SERVICE BULLETIN

EQUIPMENT: C-5000

DATE: November 20, 1998

BULLETIN NUMBER: WSB C-5000-2

Figure 1. Screw Locations to Remove C-5000 Bottom Cover

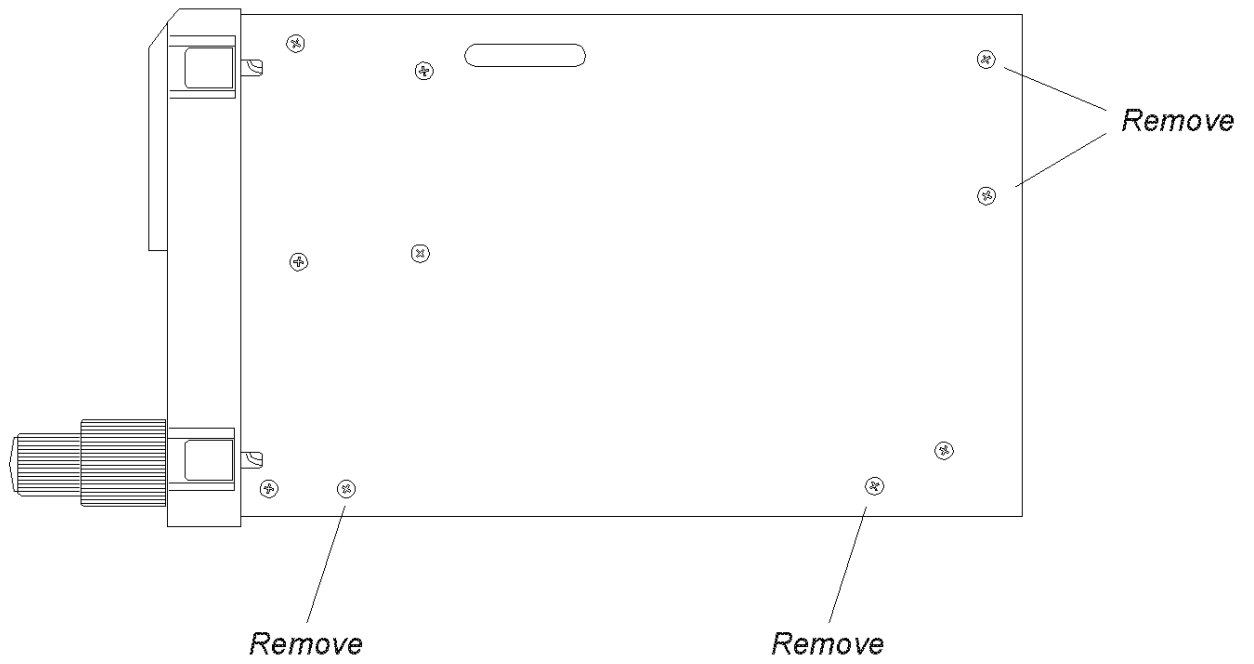
1. Remove the bottom cover of the C-5000 to access the Main Board. The bottom cover is secured to the chassis by eight Phillips-head screws, four located on the left side and four located on the right side of the unit. See Figure 1.

Figure 2. EPROM Locations

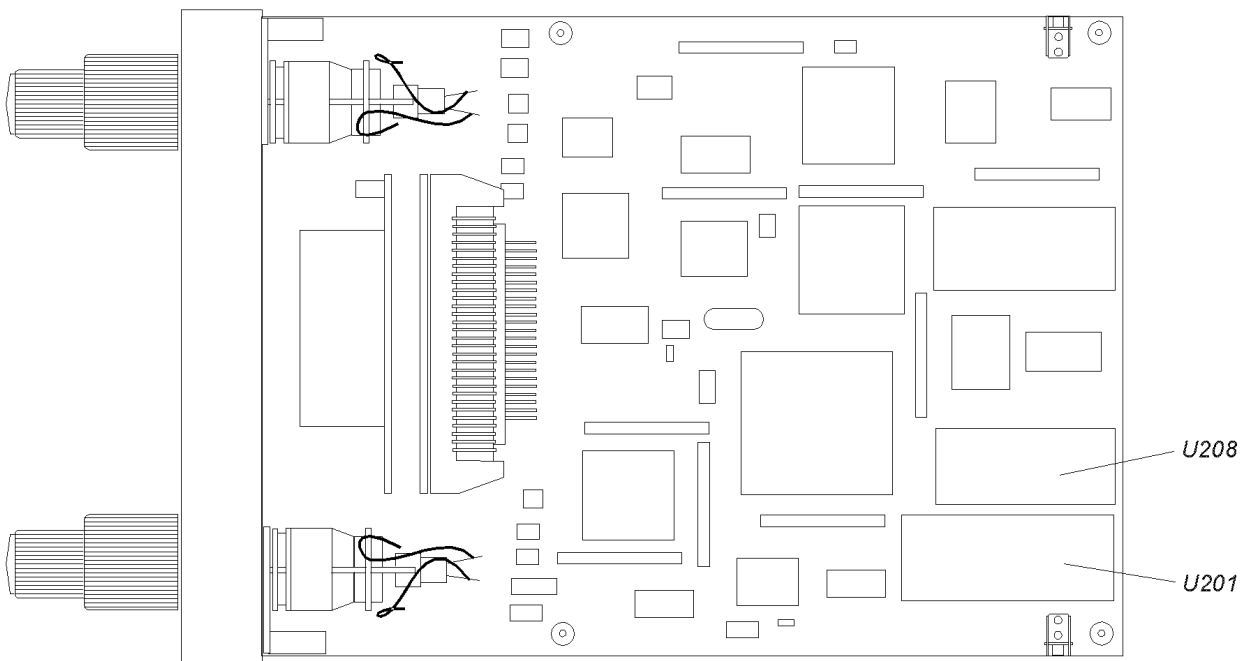
2. Remove EPROMS U201, P/N 106-816662-XX, and U208, P/N 106-816664-XX. See Figure 2.
3. Install updated EPROMS U201, P/N 106-816662-14, and U208, P/N 106-816664-14.
4. Reinstall the bottom cover.
